ENGINEERING (DRAINAGE) EVIDENCE STATEMENT

LANCEFIELD ROAD PSP &
APPLICATION FOR PLANNING PERMIT P18855

PREPARED BY ANDREW MATHESON FOR
WINCITY DEVELOPMENT PTY LTD
AUGUST 2017

Section E

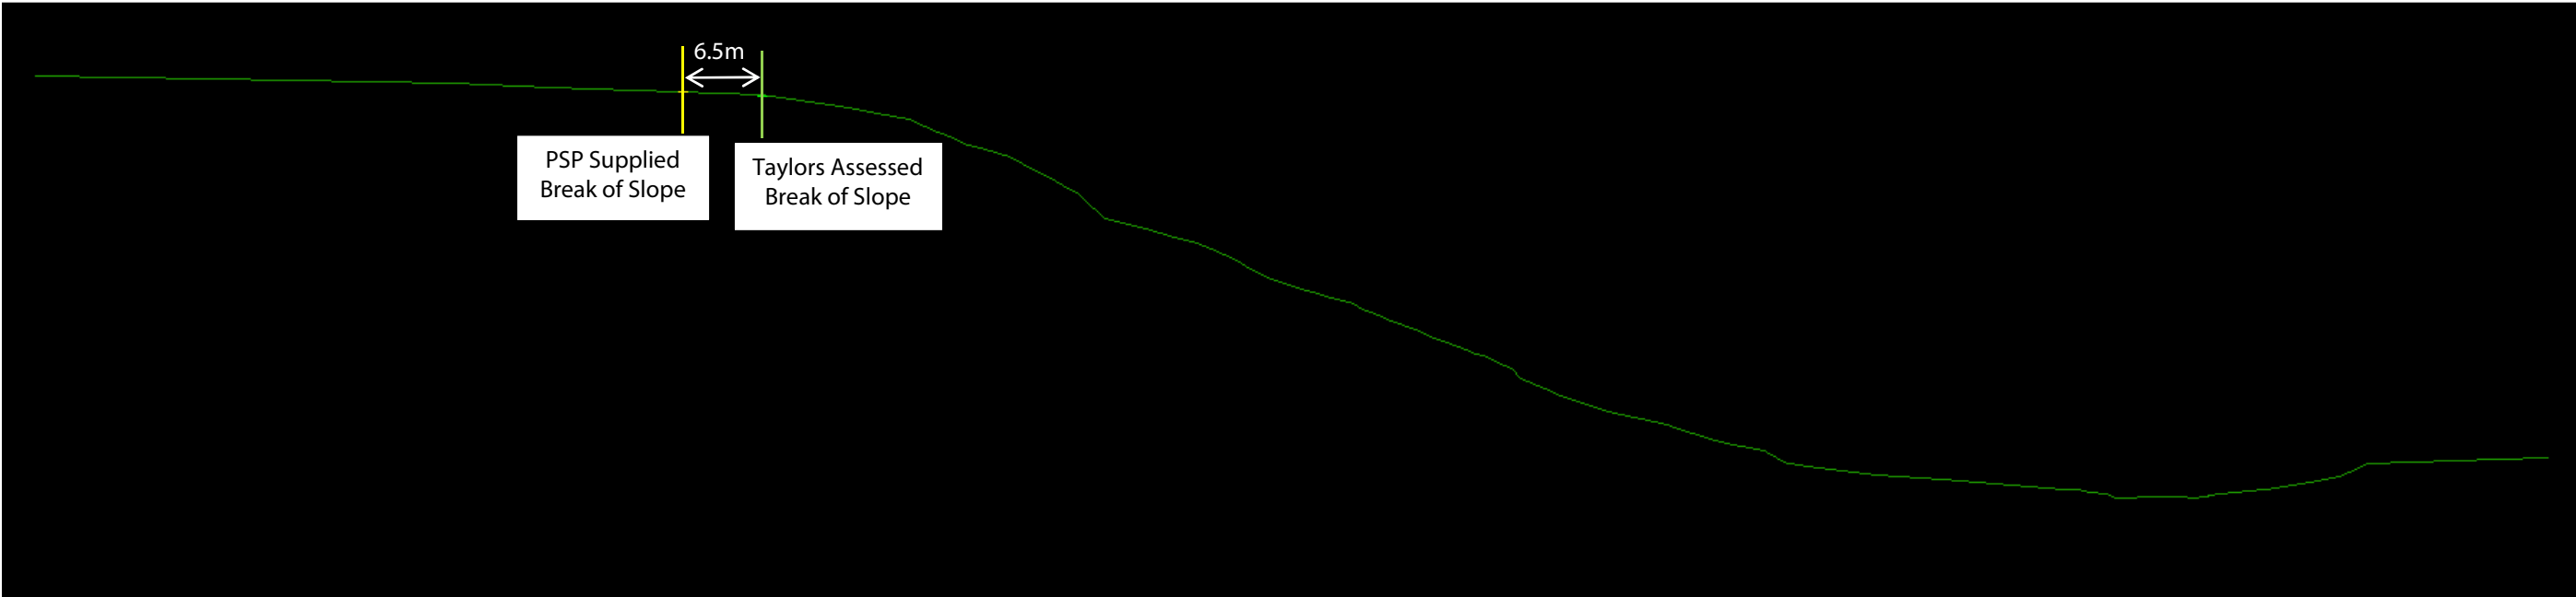
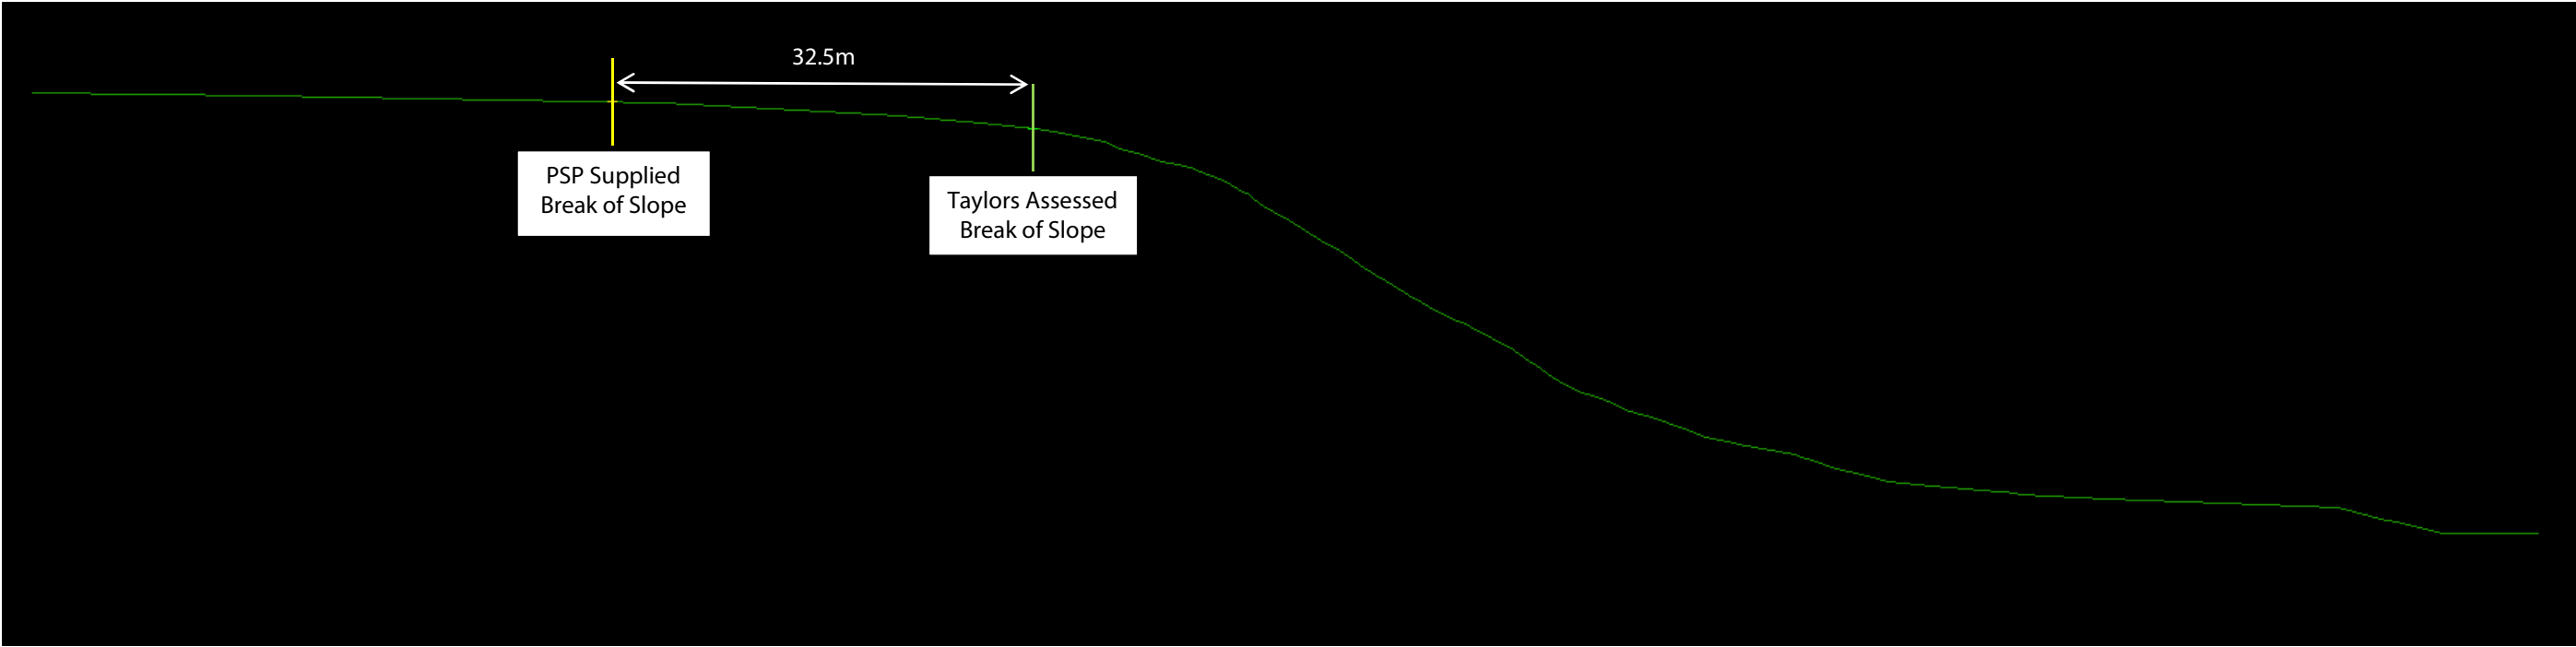
I have reviewed the revised Break of Slope line provided by the VPA and note that within the 96A Application area, the alignment has been placed satisfactorily. It is my opinion that within Title 3-22/PP2258, particularly in the north-east corner, the Break of Slope line has been incorrectly located and should be amended in accordance with scientifically assessed alignment.

WinCity have instructed me to review the break of slope line as defined by the exhibited PSP and with the revised break of slope line as provided by the VPA in May 2017. I understand that the break of slope has been defined by a 'virtual' site inspection conducted by the VPA. The exhibited PSP defines the break of slope on Plan 3 as "setback required for bush fire management, protection of visual and landscape qualities, and linear trails". The PSP also allows on the 'Local Access Street Level 1 (16m)' cross section, the development on land as steep as a 17.5% gradient. To assess the break of slope I have overlayed the supplied VPA linework on to the feature and 1 metre contour information obtained from the Victorian Government's Open Data Directory. I have examined the 1 metre contour data for abrupt changes in gradient or for areas that exceed 17.5% gradient in proximity of the VPA supplied break of slope line. It is my opinion that the VPA Break of Slope line has been incorrectly located in the north-east corner of Title 3-22/PP2258, which forms part of the Subject Land, and that the Break of Slope location which I have identified by scientific analysis should be adopted.

12. Appendix B – David Lock and Associates Revised Town Centre Concept Plan

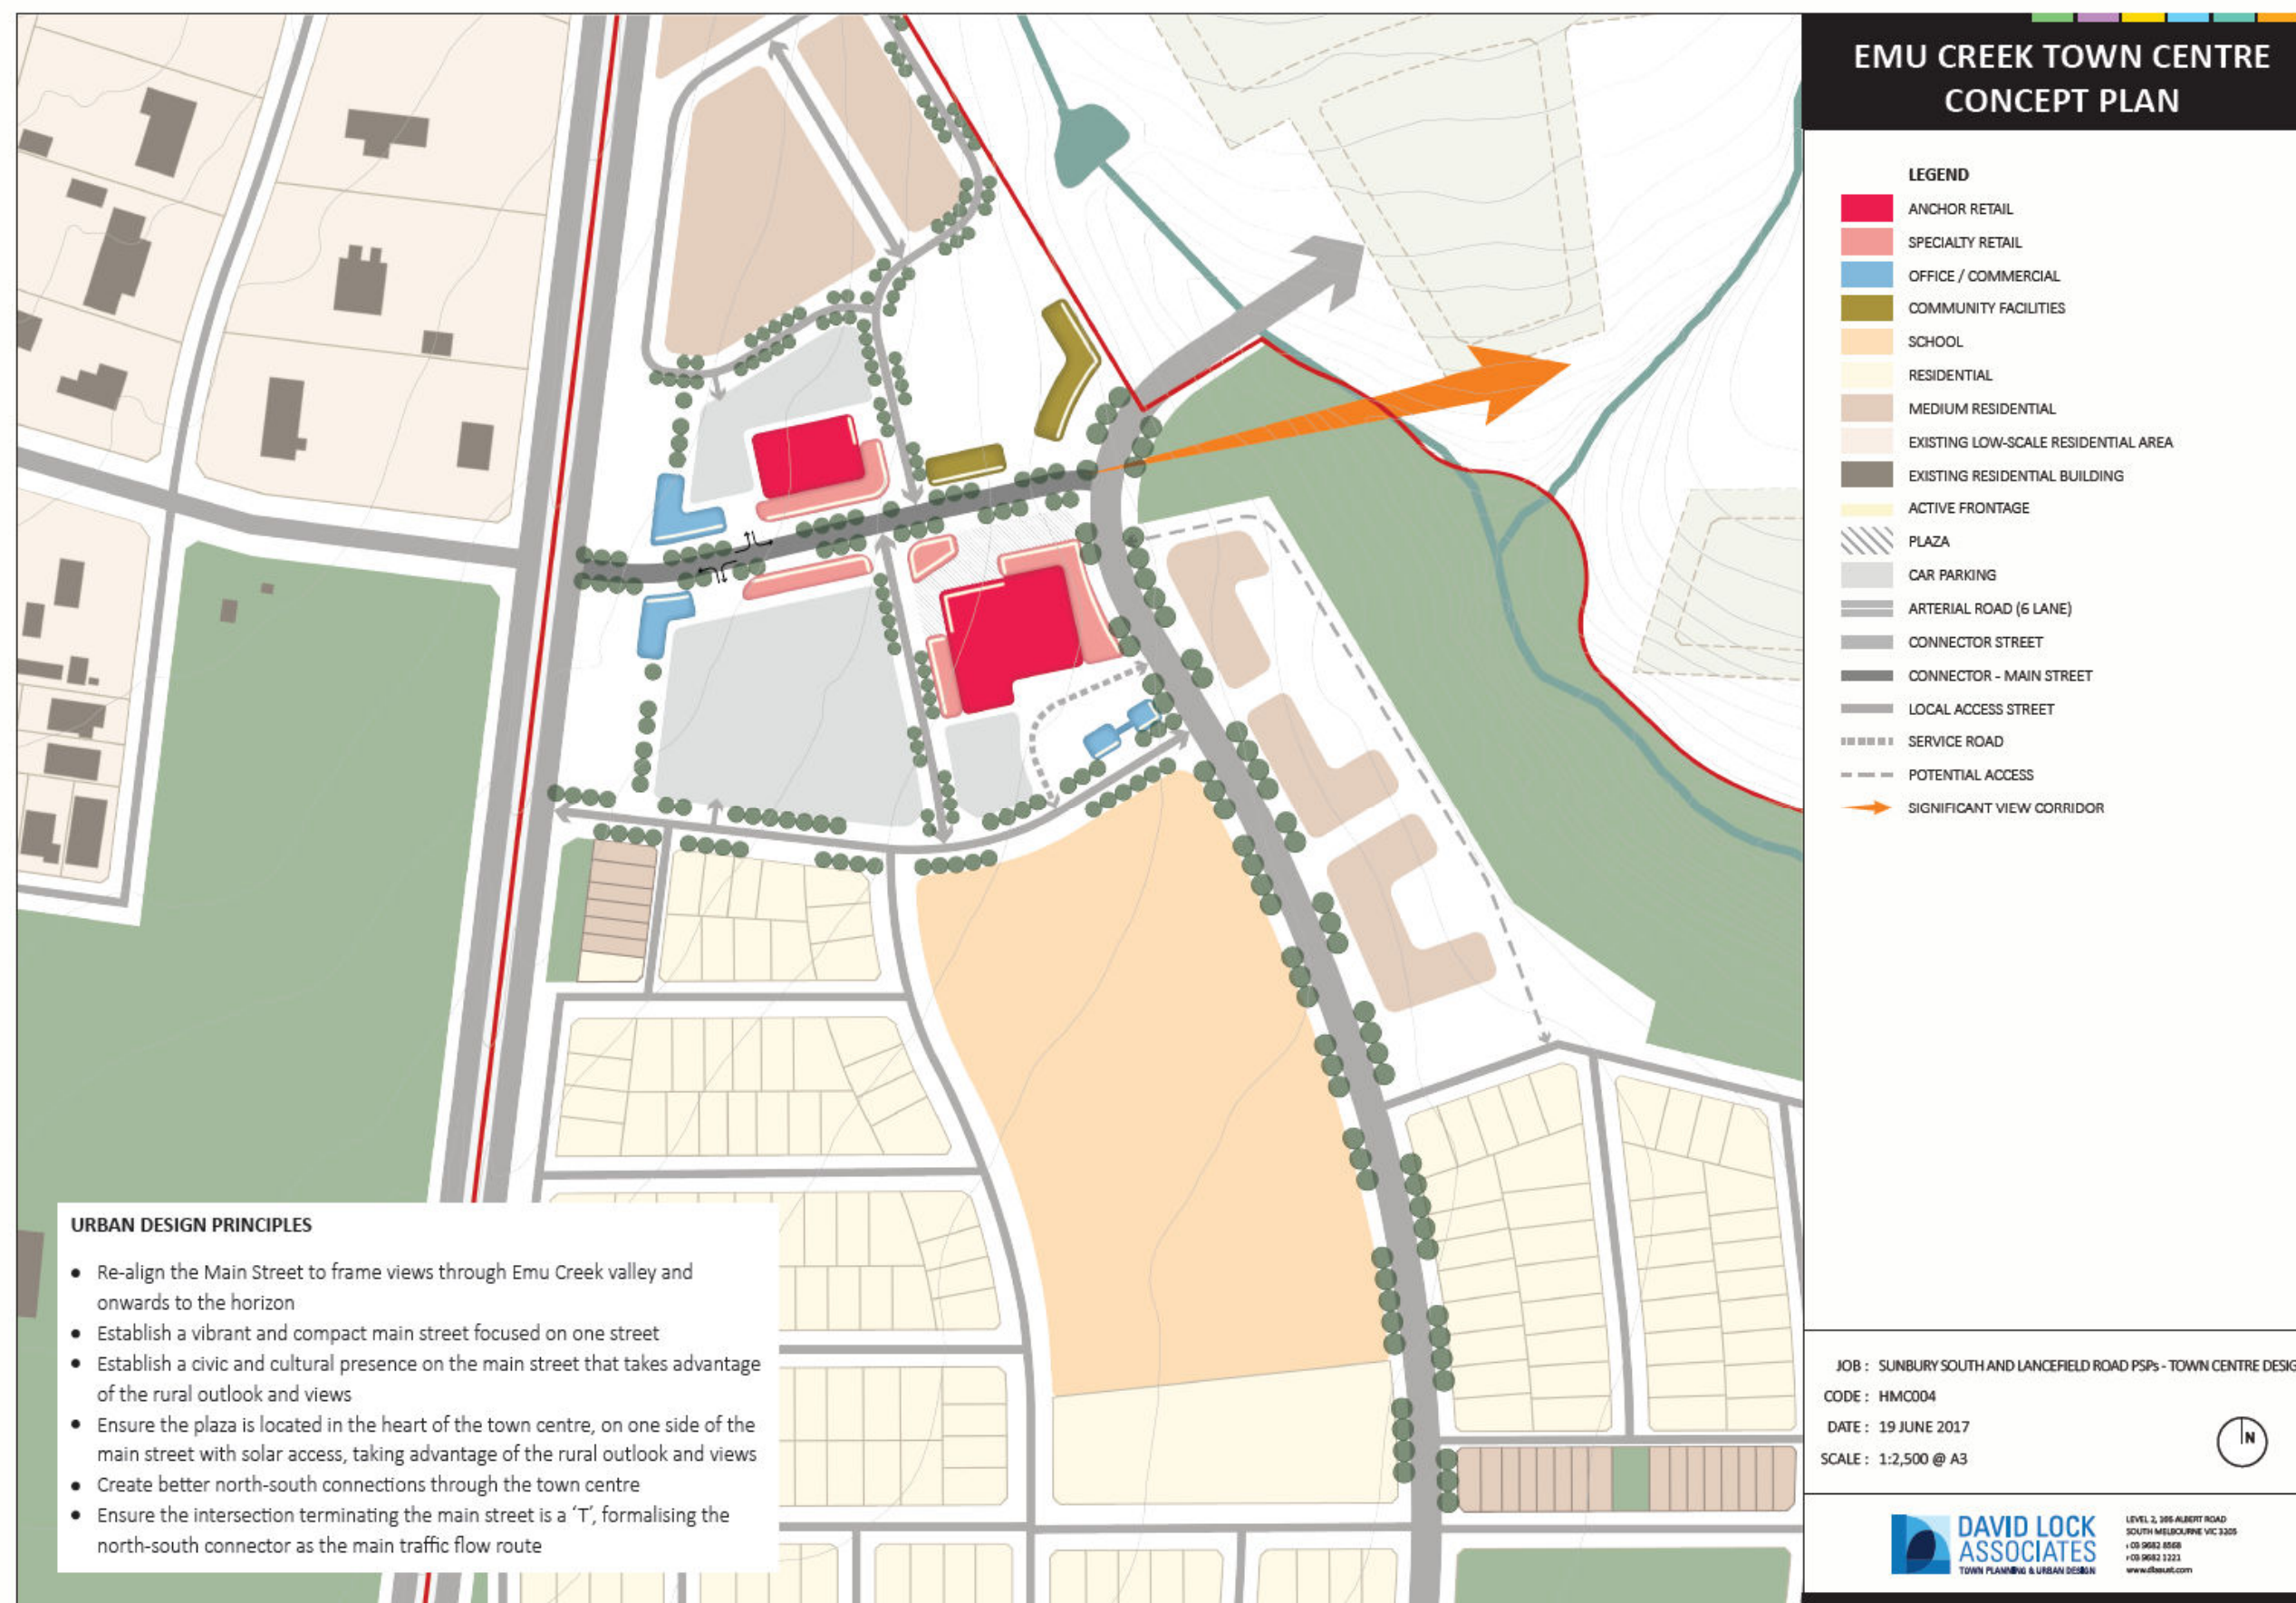
I have reviewed the David Lock and Associates Town Centre Concept Plan and compared it to the revised Melbourne Water draft Developer Services Scheme Plan. It is my opinion that there is a conflict between the location of the Community Facility and Wetland WL-15. It is my opinion that the wetland location should be retained and the Community Facility relocated.

I have reviewed the Town Centre Concept Plan design prepared by David Lock and Associates, dated 19th June 2017 (Appendix B). It is my opinion that the proposed town centre plan and the revised Melbourne Water Developer Services Scheme strategy conflicts with one another.

The MWC DSS requires that PSP exhibited wetland, WL-15, be amended so that it is positioned 'off-line' from the existing tributary that runs along the eastern boundary of the town centre site. This results in a smaller wetland/sediment pond being located above the break of slope line inside the town centre area as presented in the David Lock and Associates design plan. Directly, the revised wetland impacts on the proposed location of the Community Facilities.

It is my opinion that the Community Facilities should be relocated to allow for the proposed MWC DSS wetland to be located above the break of slope alignment, directly upstream of the proposed bridge across the adjacent tributary, for the following reasons;
